SERVICE BULLETIN

APPLICABILITY: 2017-20MY Impreza 5-Door
2018-20MY Crosstrek

NUMBER: 12-293-20

SUBJECT: Rear Quarter Glass- Design Change

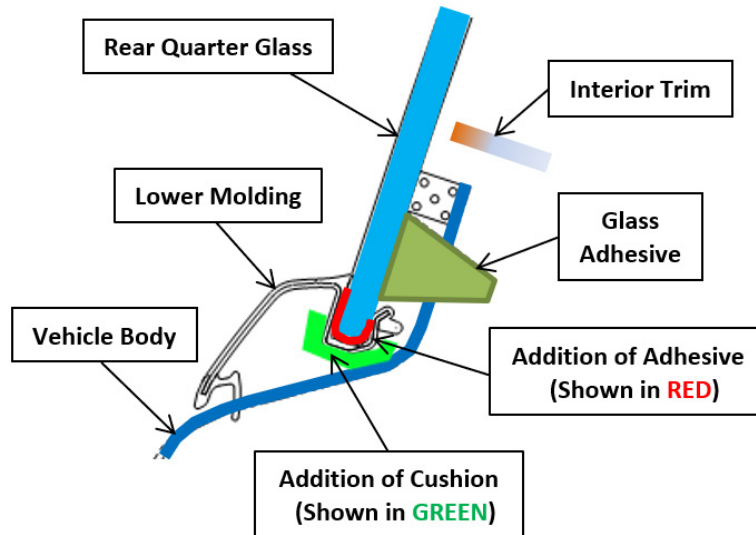
This bulletin announces design changes made to the rear quarter glass assembly in response to a small number of reports describing a rattling -type sound originating from the lower molding. In some cases, the lower molding may become loose enough to cause the condition. The changes involve:

- addition of adhesive to supplement the clamping force securing the lower molding to the glass
- a new cushion to provide insulation between the lower molding and body.

The cutaway illustration below provides detail of the changes.
